DEPARTMENT OF TRANSPORTATION**Federal Highway Administration****23 CFR Part 655**

National Standards for Traffic Control Devices; Revision of the Manual on Uniform Traffic Control Devices**AGENCY:** Federal Highway Administration (FHWA), DOT.**ACTION:** Notice of proposed amendments to the Manual on Uniform Traffic Control Devices (MUTCD); request for comments.

Figure 12

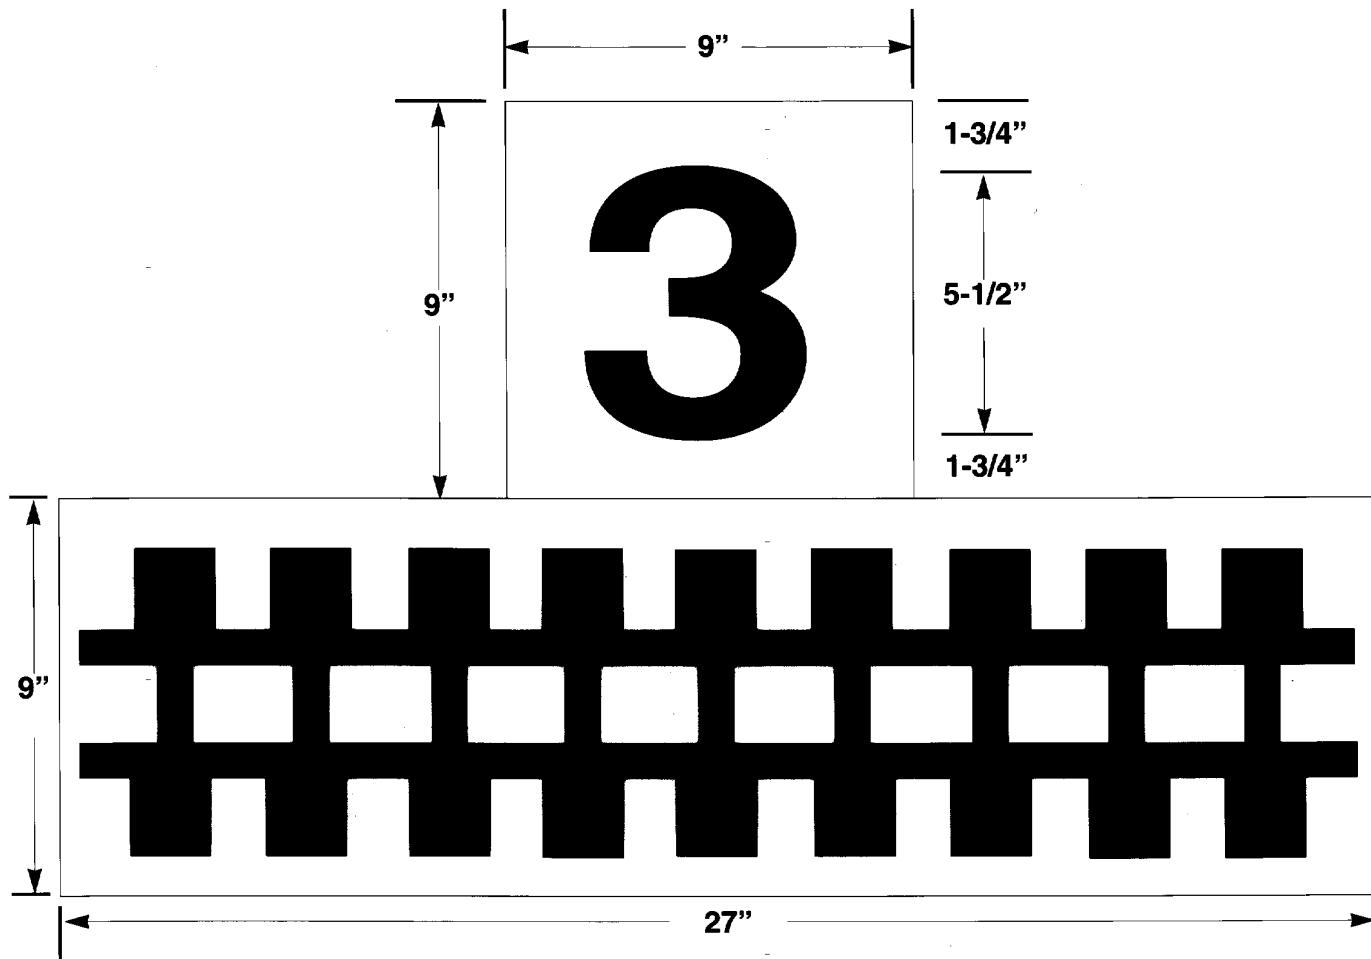
This request from a private citizen in Cheltenham, Pennsylvania, is to replace the standard Number of Tracks Sign (R15-2) with a symbol sign showing

tracks instead of the word "TRACKS." The symbol is shown below. The purpose stated for this request is to provide better understanding of traffic control signs for non-English speaking drivers.

The FHWA proposes to deny this request. The FHWA does not have any data to indicate that the standard Number of Tracks Sign is misunderstood by drivers.

Figure 13

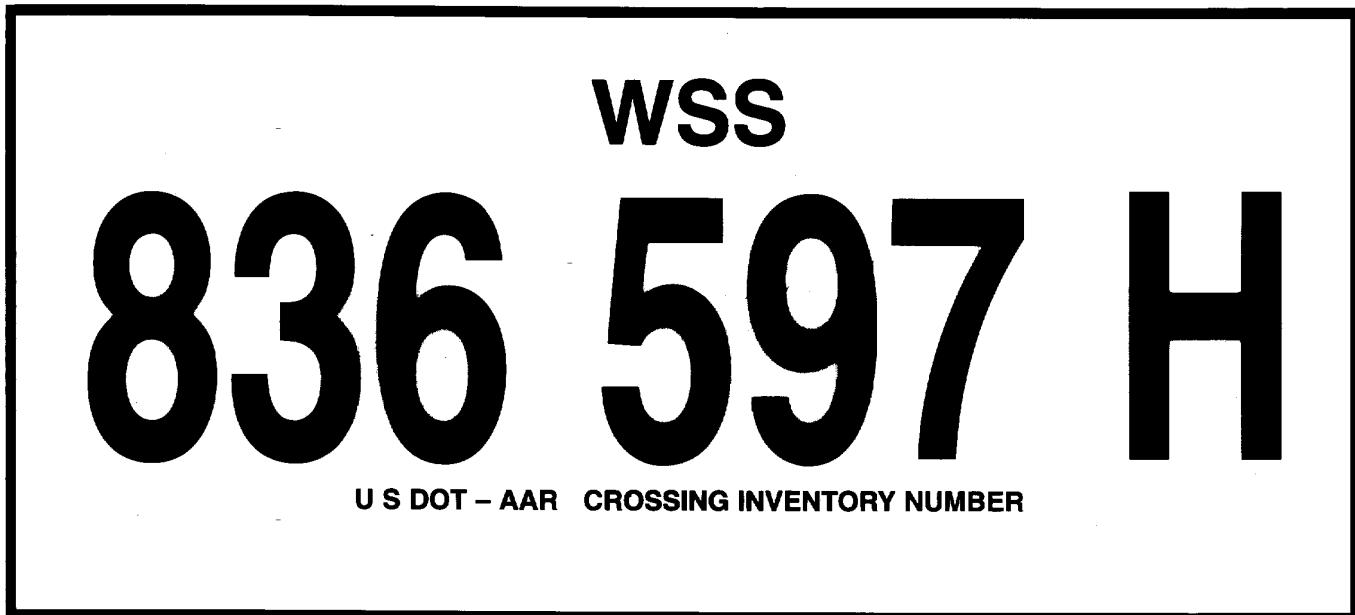
This fourth request from the FRA is to include in Part VIII of the MUTCD the standards for the design and placement of the U.S. DOT/AAR National Rail-Highway Crossing Inventory number plate. This proposal would specify the sign size, material used, and the location of the plate at the crossing. The FHWA supports this proposal for the uniformity of location and durability of this tag.
